MEETING MINUTES

Subject: Project W-178 219-S Secondary Containment Upgrades – Ecology Interface

The purpose of this meeting was to conduct a review of the M-32-02 milestone and discuss project status.

Attachment 2
Photograph of Drain Valve in T-8 Tunnel

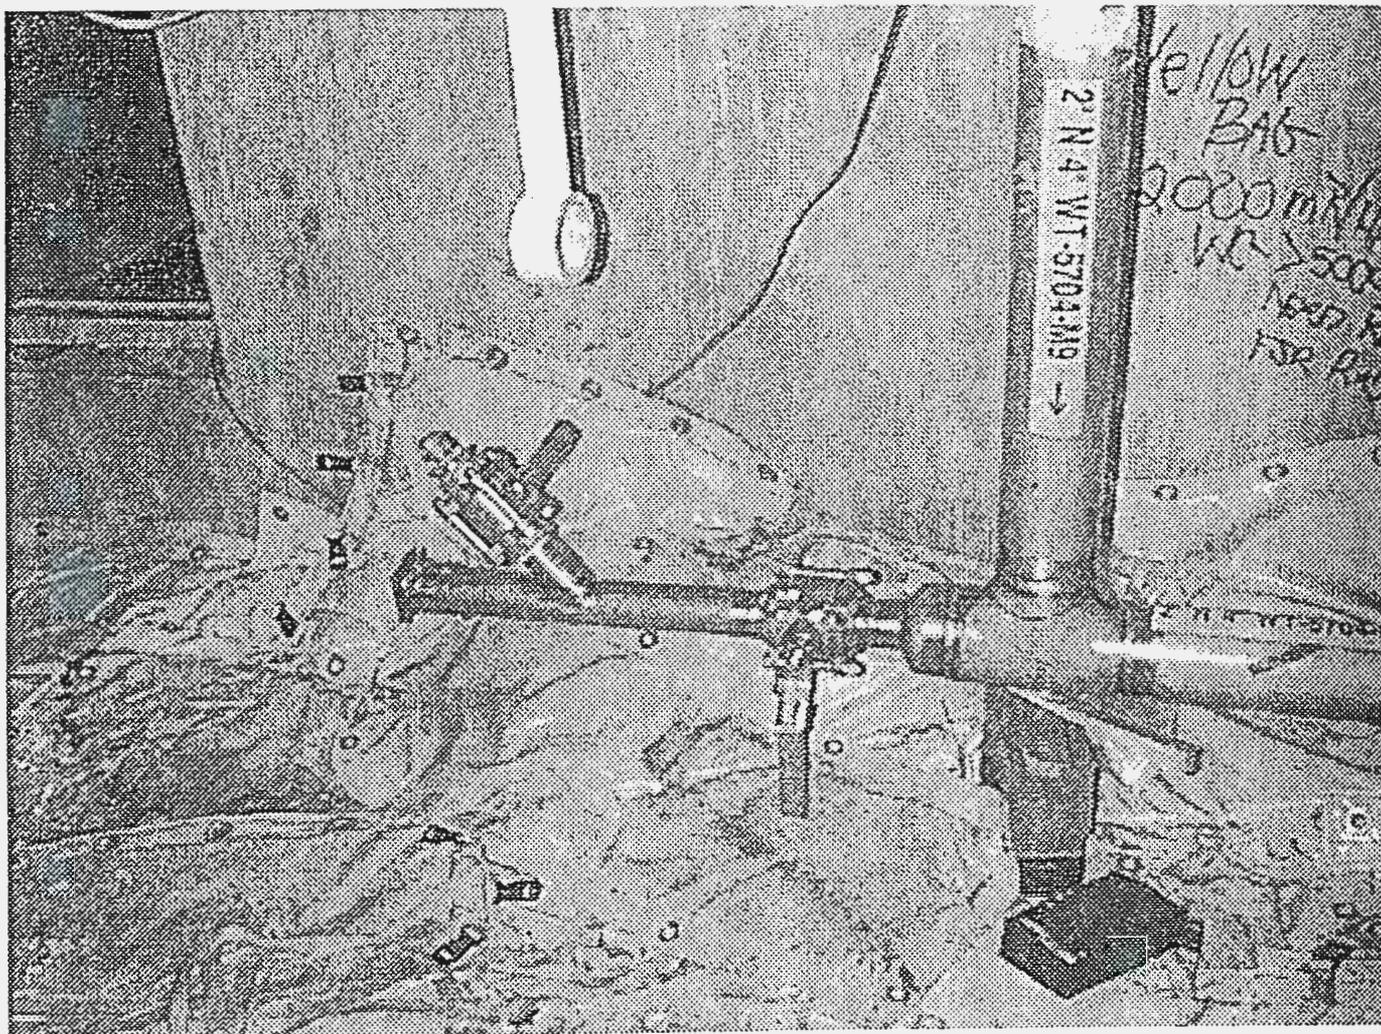
Mr. Beyer and Mr. Cahill showed Ms. Huckaby a photograph of a valve in the T-8 tunnel that they propose leaving installed for purposes of flushing the new process lines to lower radiation dose (Attachment 2). The new drain header is gravity-feed only, slopes away from the valve location, and leaves approximately 2" of the pipe (which is normally empty) without secondary containment. This section of pipe is located upstream of the normal flow and would therefore have limited contact with waste during routine operations. The potential exists for high-radiation dose residual solids from laboratory operations (e.g., tank farm samples from hot cells) to settle in the line, resulting in a significant increase in dose in the area. Should this occur, the process lines would be flushed via the valve. Experience has shown the benefit of being able to flush the line for dose reduction. The valve would provide an access point for pipe cleaning which would be of value for maintenance. Ms. Huckaby asked what sort of secondary containment, if any, would be provided. Mr. Cahill stated that because the potential for a leak was so small, none was planned and that the very low potential for any type of failure is far outweighed by the value of having this flush port available. It was concluded that concurrence would be sought from the independent qualified registered professional engineer (IQRPE) documenting the "value" versus "risk" in the assessment. Ms. Huckaby agreed with the recommendation, pending concurrence of the IQRPE in the assessment.
